This note is related to our iMX RT1176 uCOM boards (product numbers: EAC00377 and EAC00381), revisions PA4, A and PB1. Only a few boards have been released of these initial board versions. At the time of writing, the current board revision is C1 and the issue no longer exists.

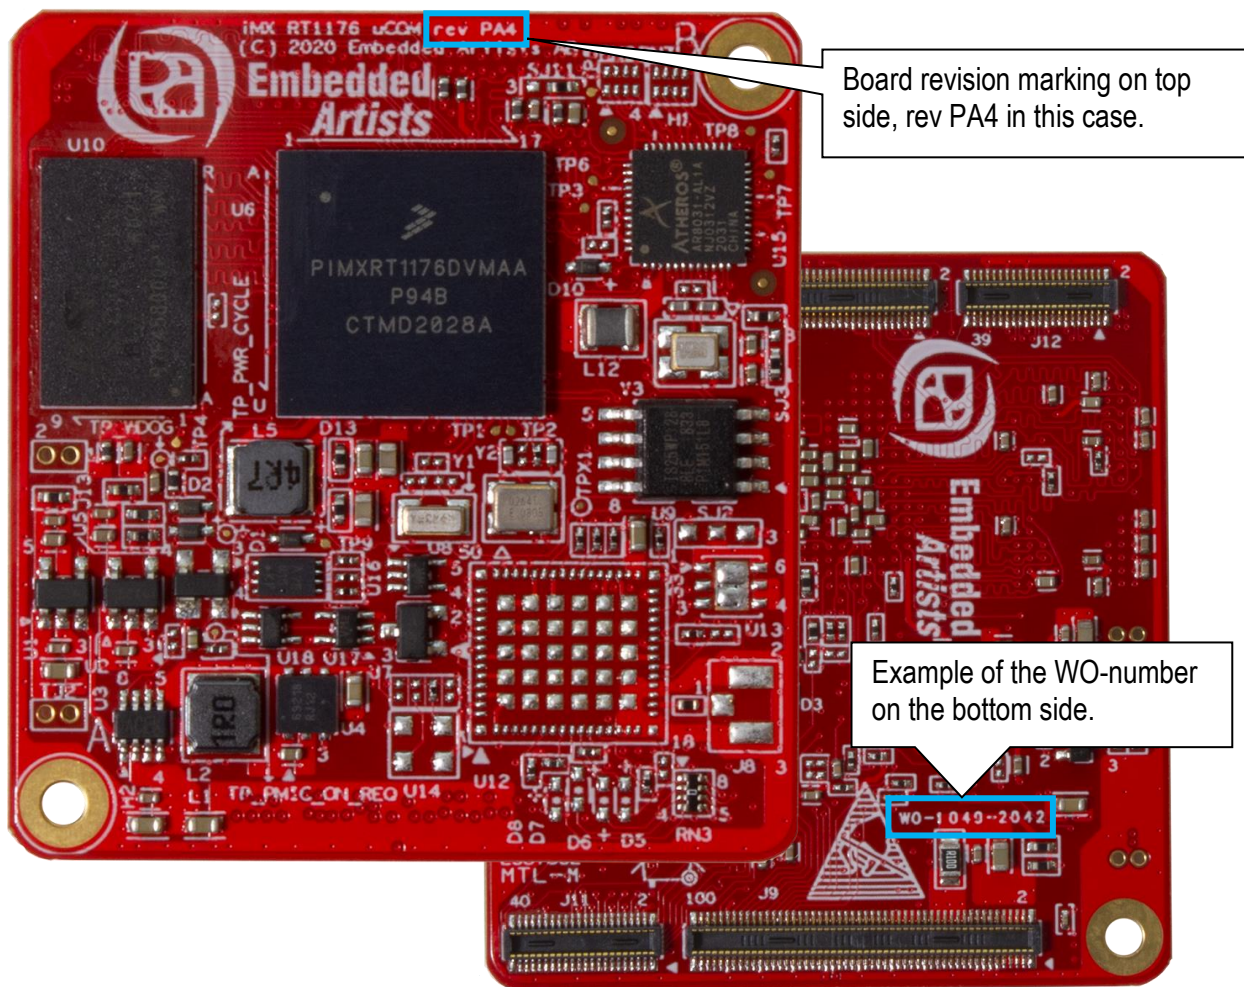
The voltage signaling level on the MDC/MDIO signals is 1.8V and this is out-of-spec. We have not experienced any problems during production test but under some circumstances it can be impossible to communicate with the Ethernet-Phy over the MDC/MDIO interface.

The solution is simple and only requires a small rework, see below. Remove one resistor on the top side and mount one on the bottom side. The signaling voltage is changed to 2.5V.
